**NOTICE OF A REGULAR MEETING
BONDURANT PLANNING AND ZONING COMMISSION
JUNE 24, 2021**

TITLE: RESOLUTION NO. PZ-210624-12 - Considering recommended approval of the Commerce Crossings Phase 2 site plan.

TITLE: RESOLUTION NO. PZ-210624-13 - Considering recommended approval of the Dvorak Preliminary Plat.

EXTERIOR
ELEVATIONS

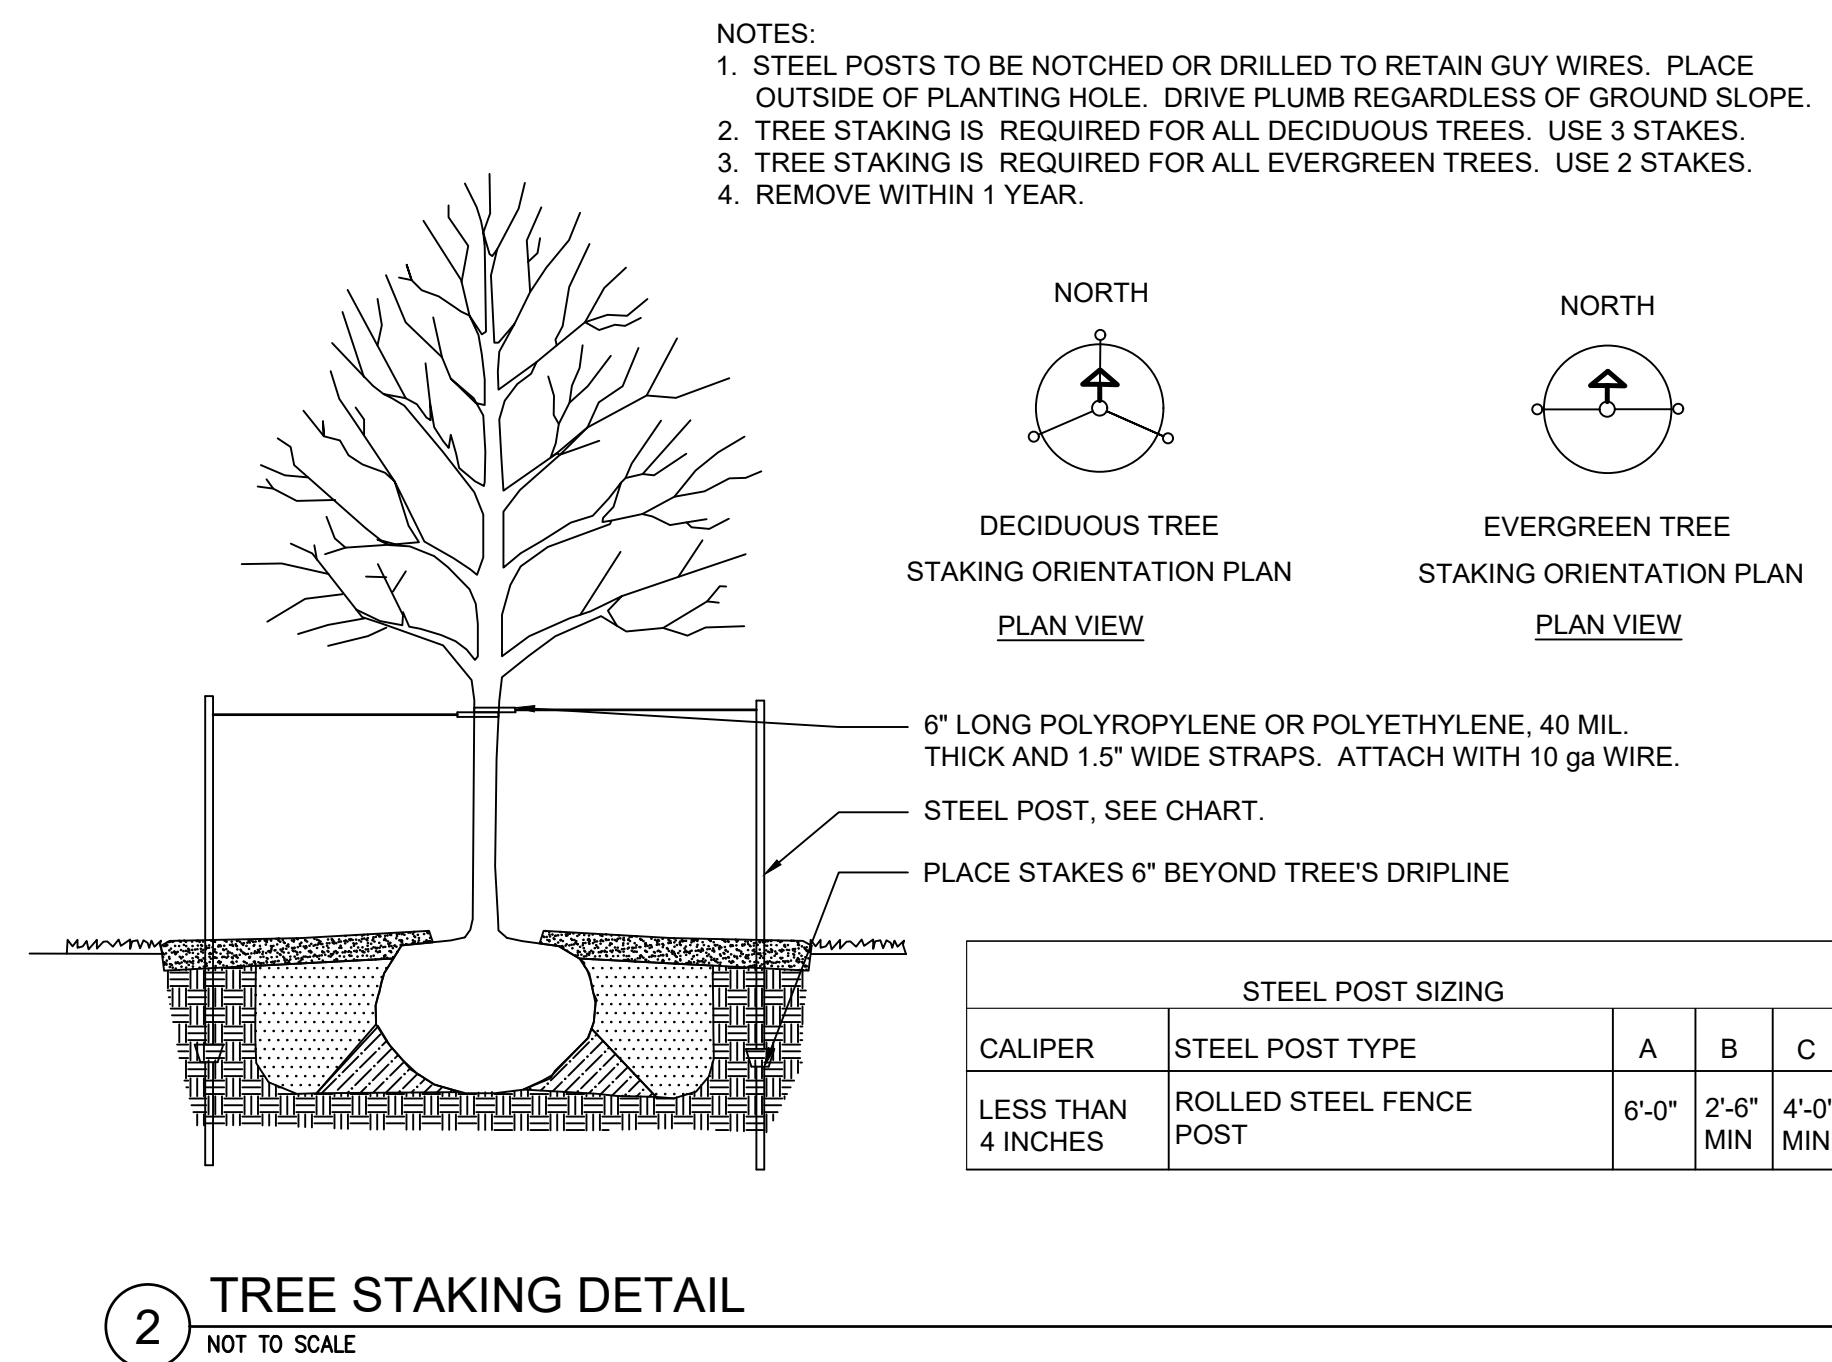
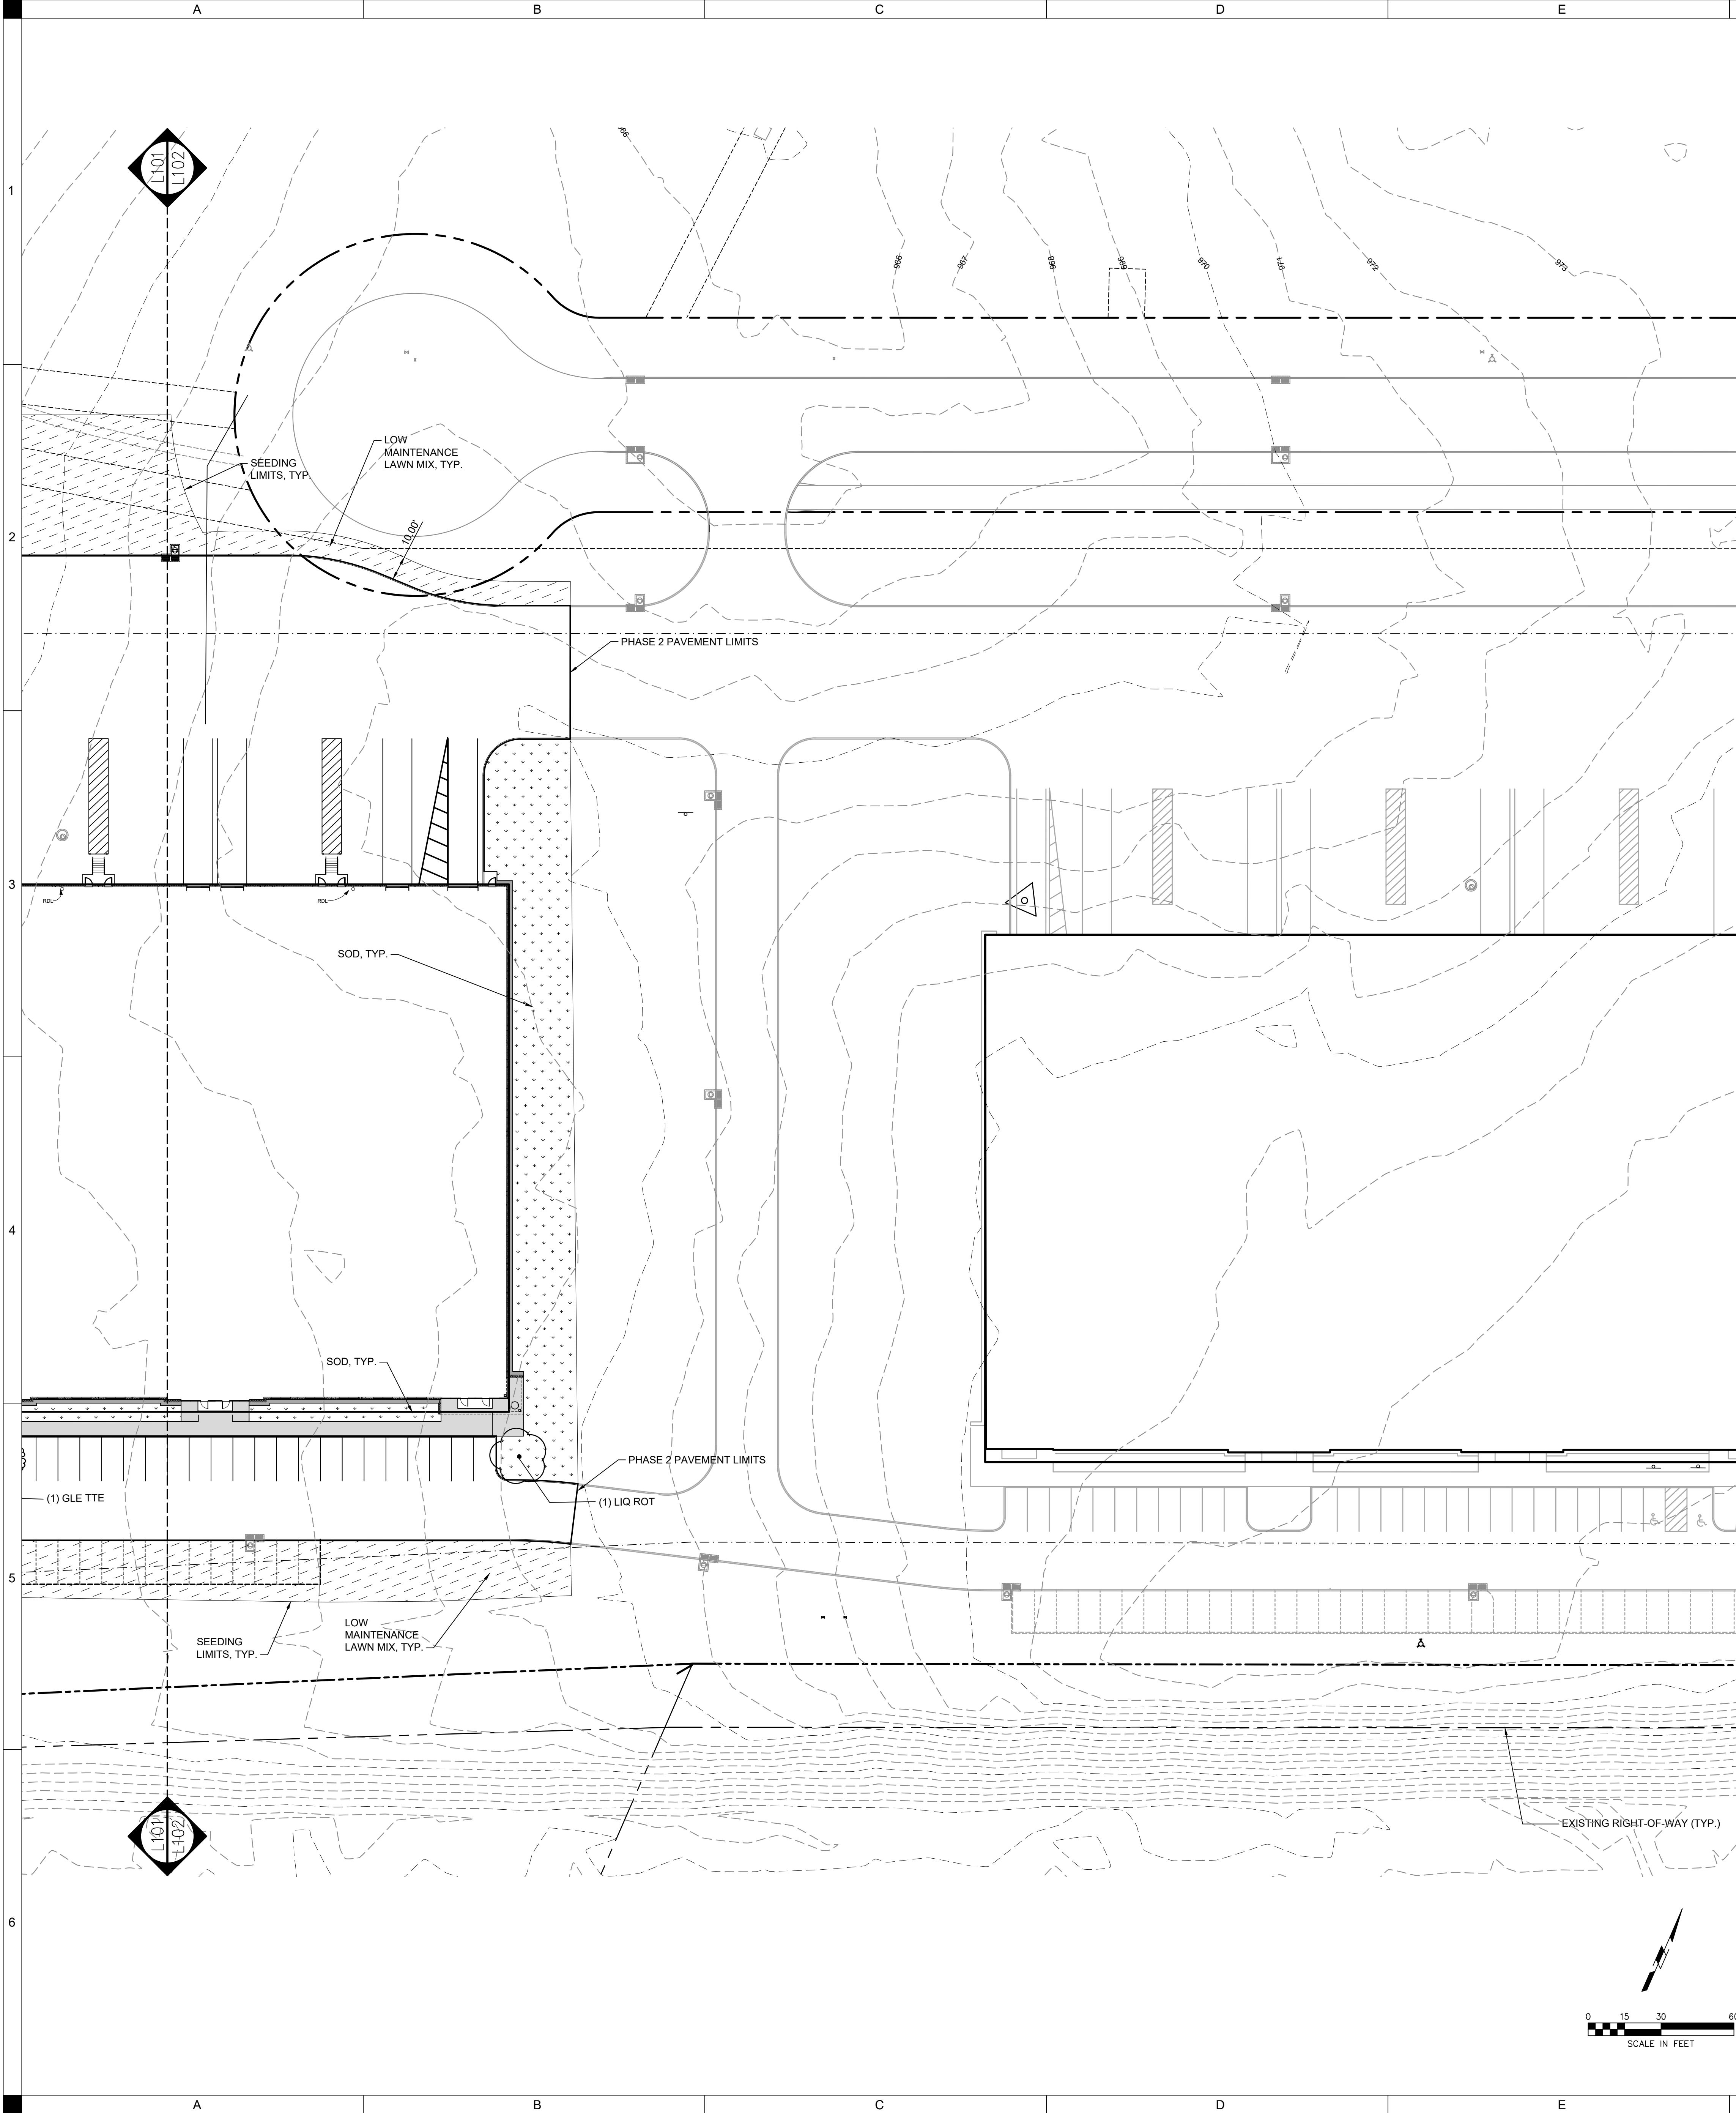
1. Attached are the elevations. These elevations show the building will be constructed with precast concrete wall panels; this meets the building material requirement for M-1/M-2 Districts not in an Overlay.
2. Below are three items that must be addressed prior to Council consideration:
 1. To address that there will be adequate treatment or screening of loading docks, loading areas, and garbage dumpsters from any public street and adjoining properties. Typical screening methods include berms and/or living screen.
 2. To address that there will be façade modulation along the Commerce Street SW-facing elevation. The Zoning Code notes the

purpose of this requirement is to preserve building scale and reduce the effect of long, large, or expansive wall surfaces. Methods of façade modulation: use of physical offsets or through use of color, pattern, or texture.

3. To confirm that roof mounted mechanical units will be screened from view of public right-of-way by the extension of a parapet wall or other screening materials having similar design features as building.

5. Elevations to address that there will be façade modulation along the Commerce Street SW-facing elevation. Methods of façade modulation: use of physical offsets or through use of color, pattern, or texture.

6. Roof mounted mechanical units will be screened from view of public right-of-way by the extension of a parapet wall or other screening materials having similar design features as building.
